APPLICATION FOR
CONSTRUCTION OF
PAVED
SIDEWALK/ DRIVEWAY

Application No. 11624

Driveway Review Form

Address: 522 Oliver St

522 Oliver St

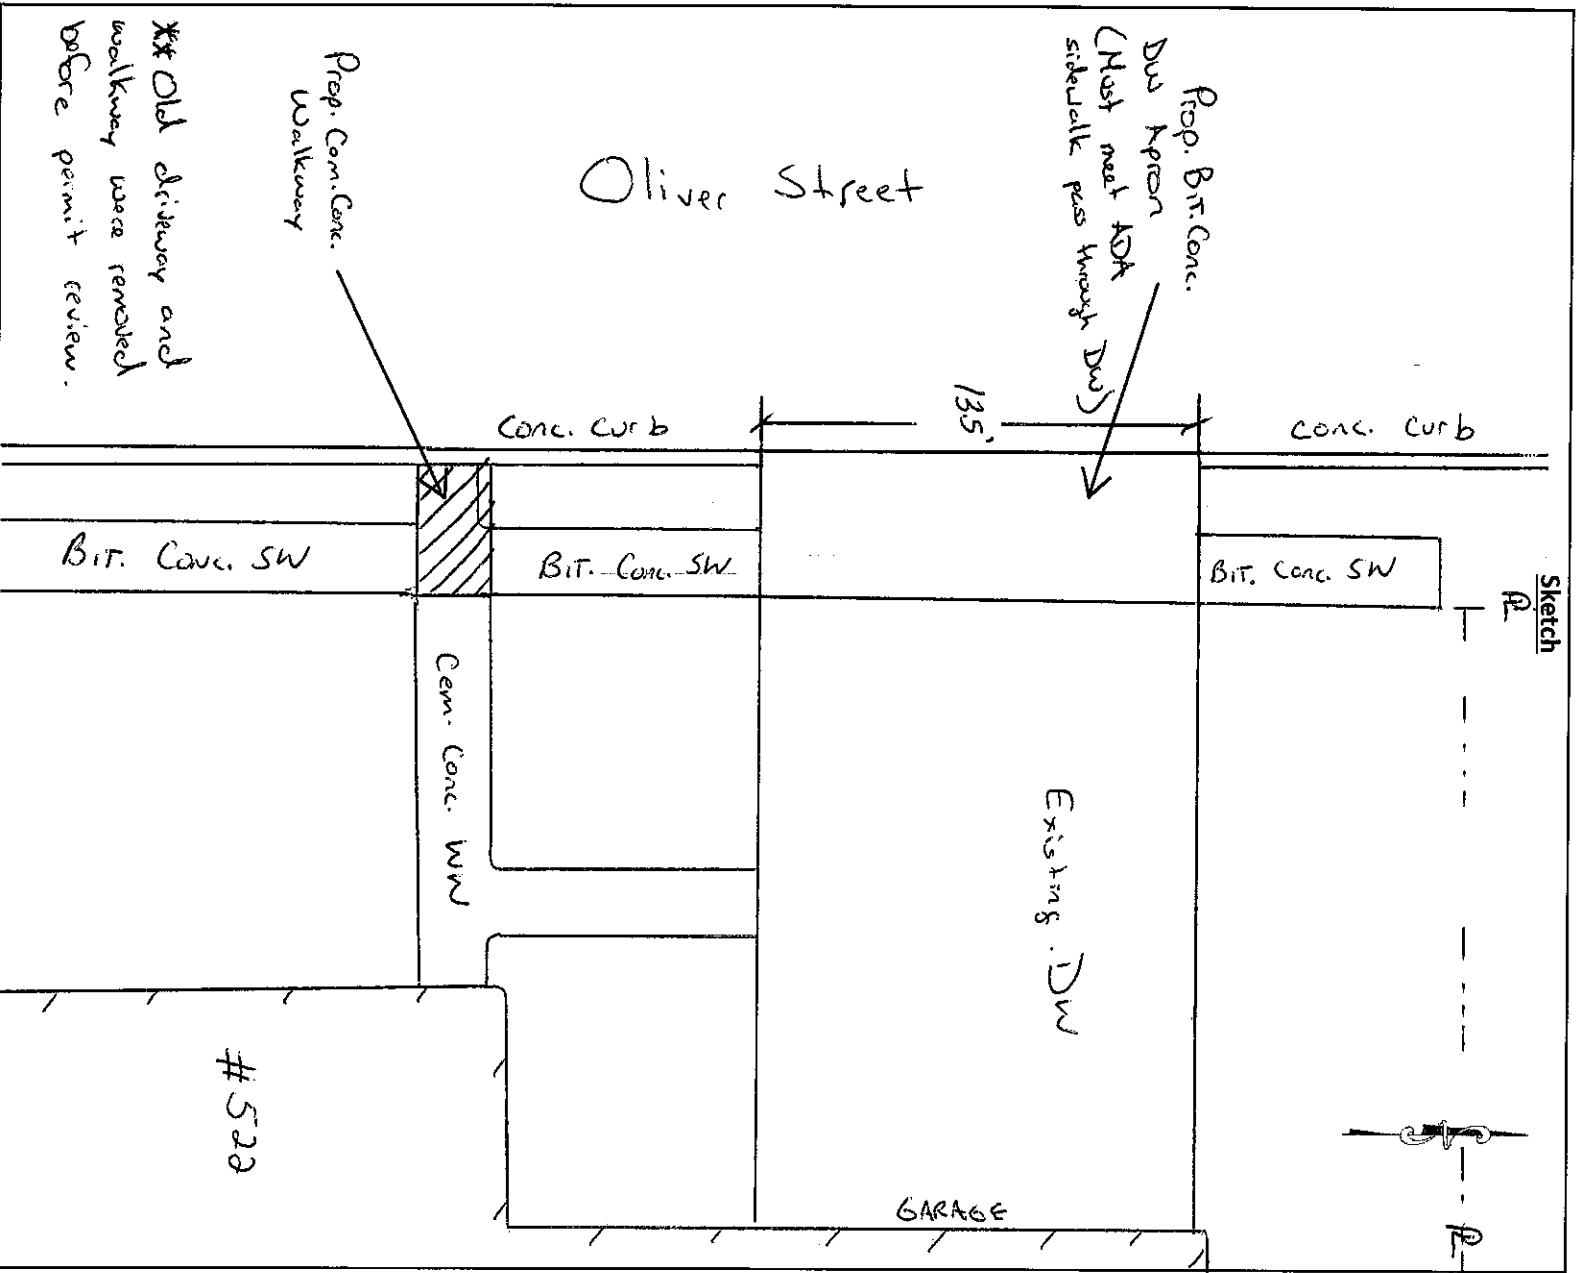
Additional Inspection Notes: **Old driveway and walkway removed prior to permit review.

1. Install new 13.5' x 10' bit.conc. DW apron in accordance with the most current DPI Construction Specs. (**Apron must pass ADA SW through DW grading requirements).
2. Install new cem.conc. walkway through sidewalk to curb edge.
